**Pacific Gas and
Electric Company®**

October 15, 2007

License Amendment Request 07-04

Proposed Technical Specifications Change to Relocate Surveillance Test
Intervals to a Licensee-Controlled Program (Risk Informed Technical Specifications
Initiative 5b)

Figure 1. Surveillance Frequency Control Program Change Process

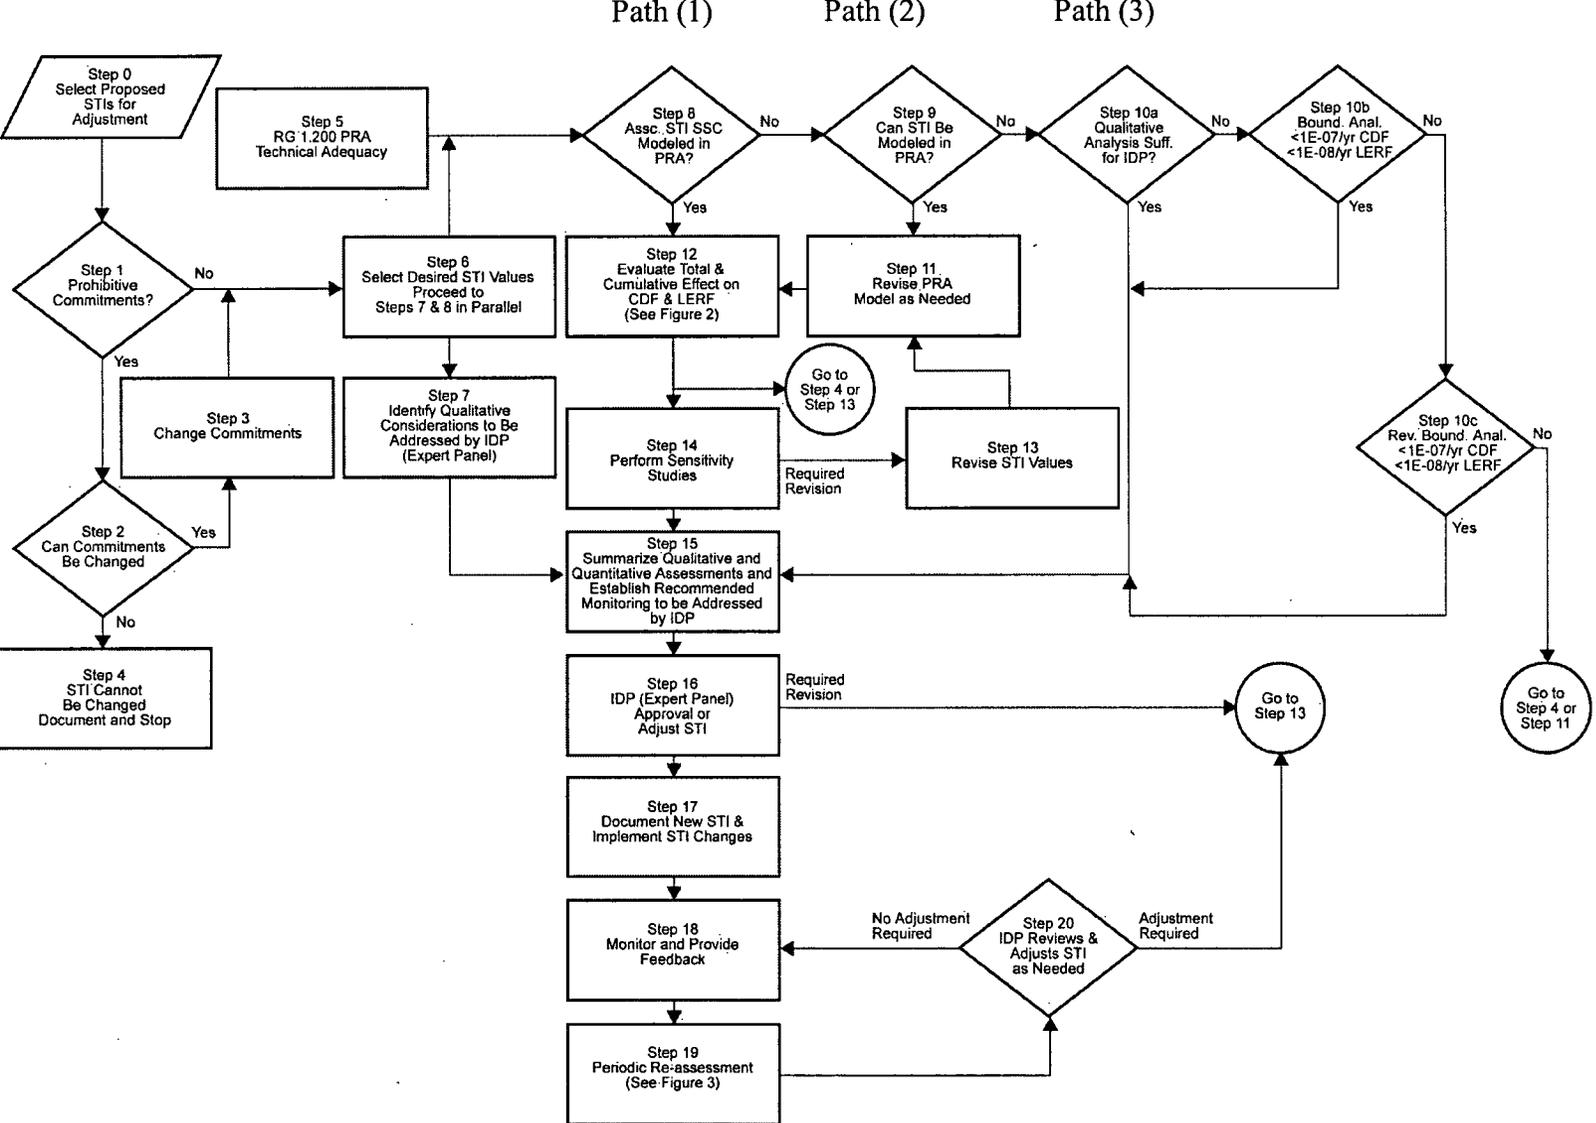
Figure 1 in NEI 04-10 provides a process flow map for the SFCP. The process includes three different branches to follow depending on how PRA is modeled, as shown in Figure 1 below in steps 8, 9, and 10:

Three process paths are identified on the marked up figure below as Path (1), Path (2), and Path (3).
